## FY 2024-25 Standard Plans Update Training

Rick Jenkins, P.E.
State Standard Plans Engineer
Central Office, Roadway Design Office
Rick.Jenkins@dot.state.fl.us

### 2024-25 Standard Plans Revision Log

# **Sheet 1: Splice**

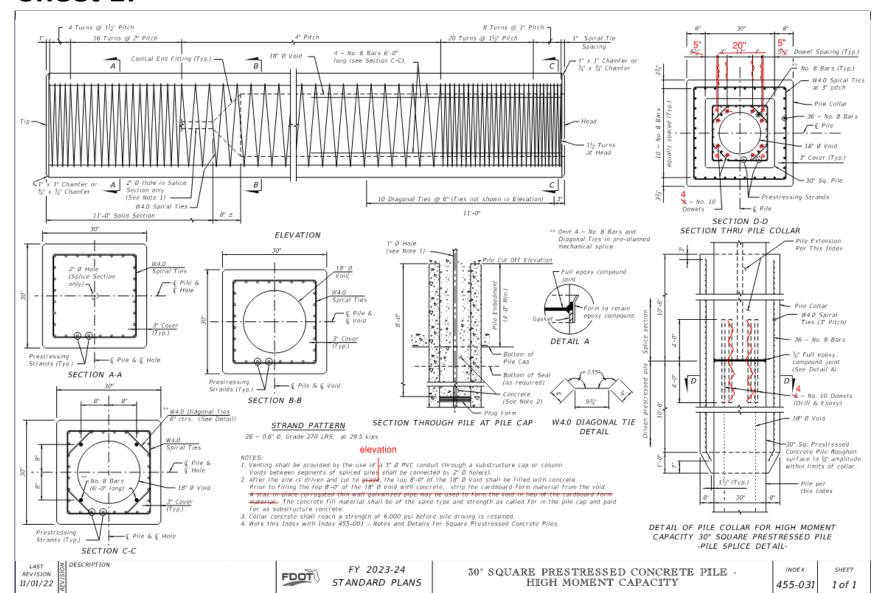
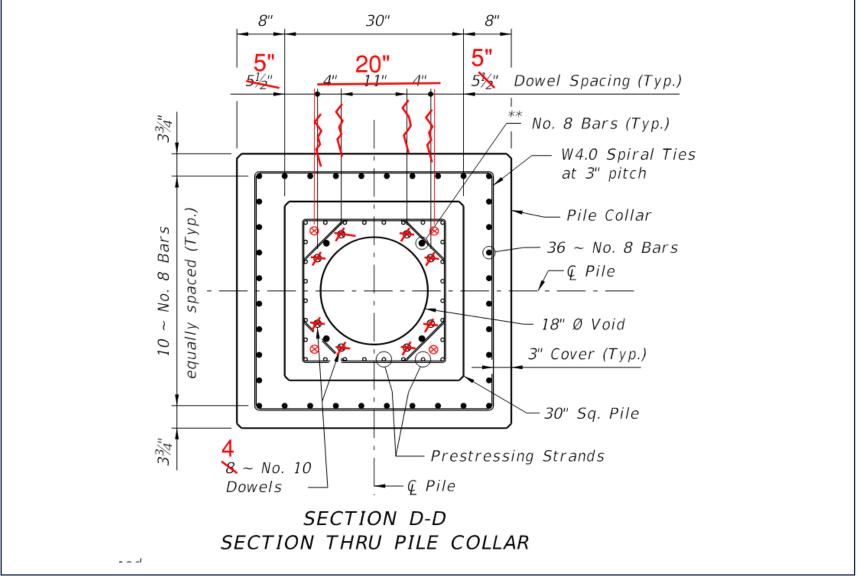
- Revised splice
- Removed corrugated galvanized pipe

- Revised splice
- Removed corrugated galvanized pipe

#### **Sheet 1:**

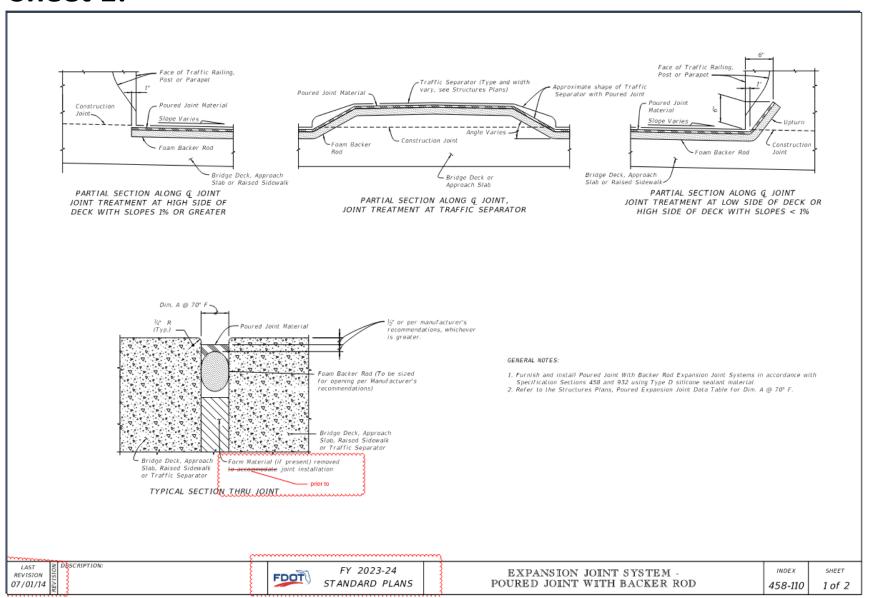
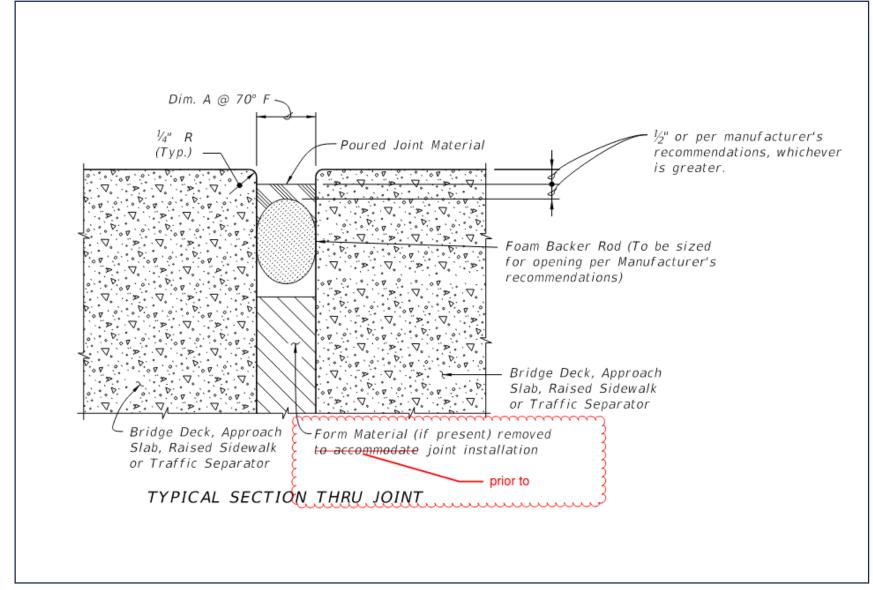
Modified note for Form Material Removal

Modified note for Form Material Removal

# Index 550-011 - BRIDGE FENCING (CURVED TOP)

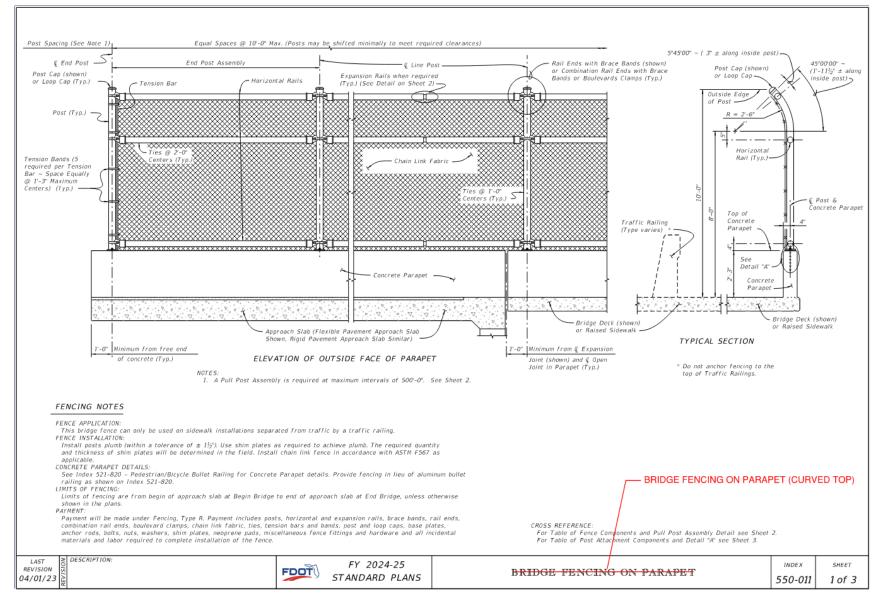
Revised Title

# Index 550-012 - BRIDGE FENCING (ENCLOSED)

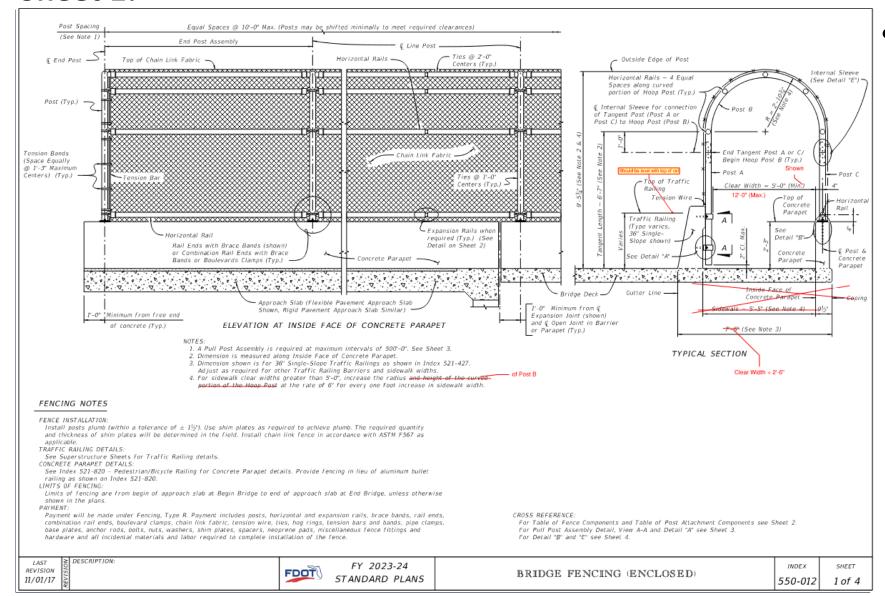
Revised Dimensions

# Index 550-013 - BRIDGE FENCING (OVER RAILROAD)

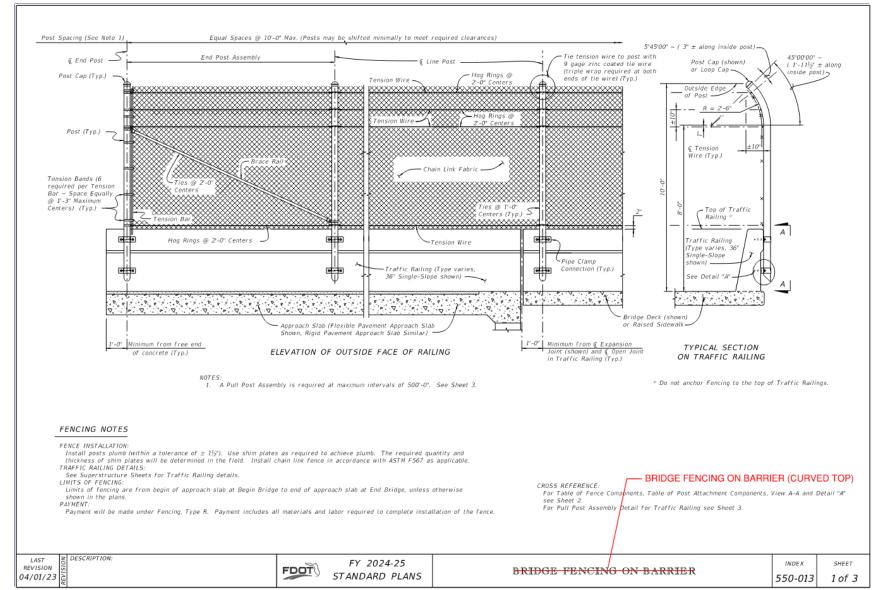
Revised Title

#### **Sheet 1:**

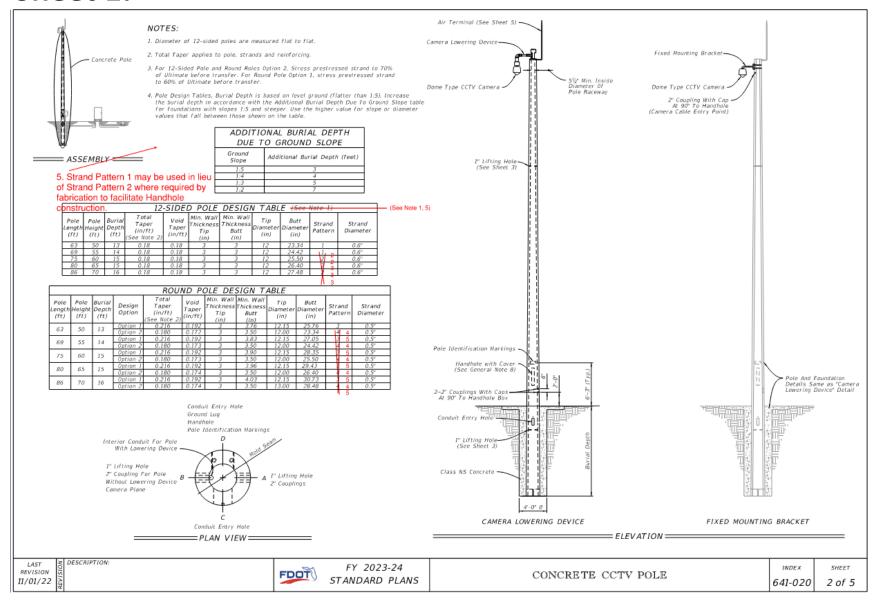
Added new strand pattern

### **Sheet 2:**

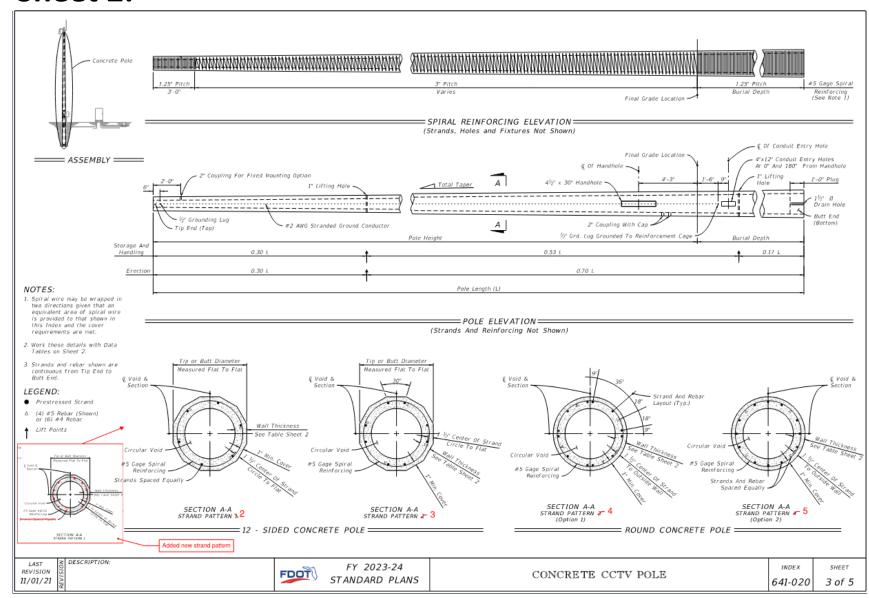
Added new strand pattern
